# Service-Information Motorcycle

Group: 16  
Fuel Tank  
and Lines

December, 1992  
16 017 92  
(2565)

## Fuel Tank Cap - All K-Models from 1986

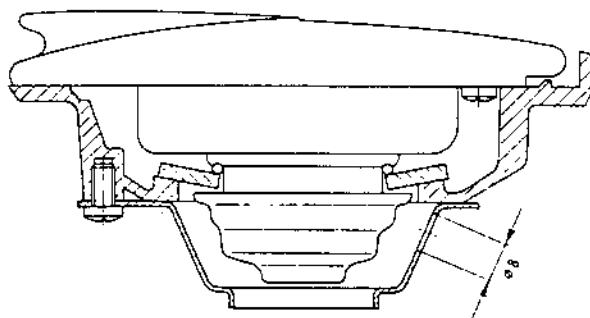
**Situation:** Since the introduction of the shed system in 1986, the fuel tank cap has had a smaller opening for the gas filler nozzle.

**Problem:** Due to the smaller opening, vapors cannot escape the tank and refueling to capacity is difficult.

**Remedy:** Remove the fuel cap assembly and enlarge the small 3.5 breather hole to 8mm (see drawing).

**Caution:** Do not attempt to enlarge the breather hole while the fuel cap is mounted to the tank as contaminants will fall into the tank.
